Service Bulletin

Bulletin No.: 16-NA-010

Subject: Front Strut Shaft Contacting Hood Due to Premature Strut Mount Wear

Brand:	Model:	Model Year:		VIN:		Engine:	Transmission:
		from	to	from	to		
Chevrolet	Caprice PPV	2011	2013			All	All

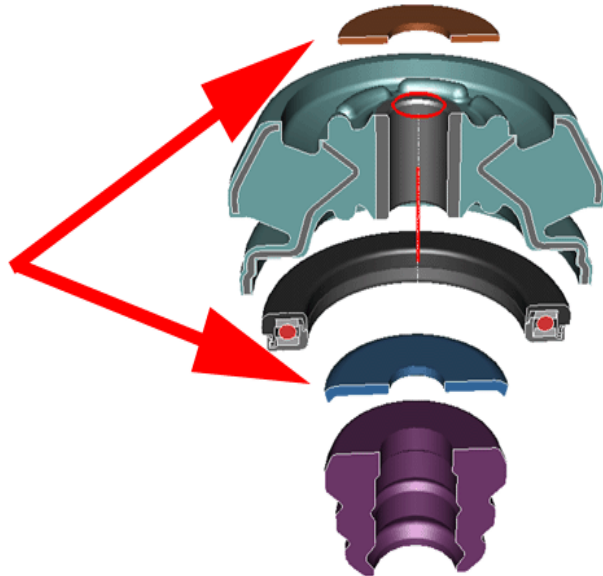
<p>Condition</p>	 <p style="text-align: right;">4356278</p> <p>Some customers may comment that the front strut shaft has come free from the strut mount and made contact with the vehicles hood.</p>
-------------------------	--

<p>Cause</p>	 <p style="text-align: right;">4356276</p>
<p>This may be caused by premature wear within the front strut mount.</p>

If you encounter a vehicle that exhibits the above condition, replace both the front struts with Part Numbers 92263478 and 92263479 in addition to replacing the front strut mounts. Refer to *Strut, Strut Component, or Spring Replacement* in SI.

Important: Unlike the previous design, the top and bottom washers are now unique. The top washer is Part Number 92273396 and the lower washer is Part Number 92421239 and must be oriented with the flat surface facing upwards.

4360818

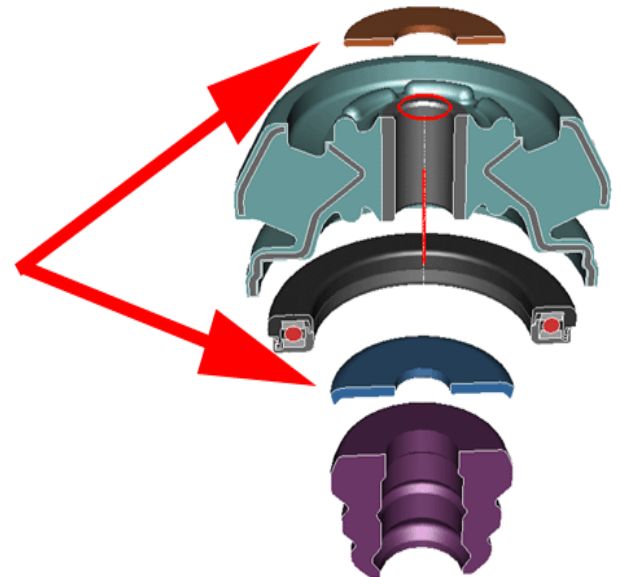
2012-2013 Model Years

If you encounter a vehicle that exhibits the above condition, replace the front strut mounts. Refer to *Strut, Strut Component, or Spring Replacement* in SI.

Important: Unlike the previous design, the top and bottom washers are now unique. The top washer is Part Number 92273396 and the lower washer is Part Number 92421239 and must be oriented with the flat surface facing upwards.
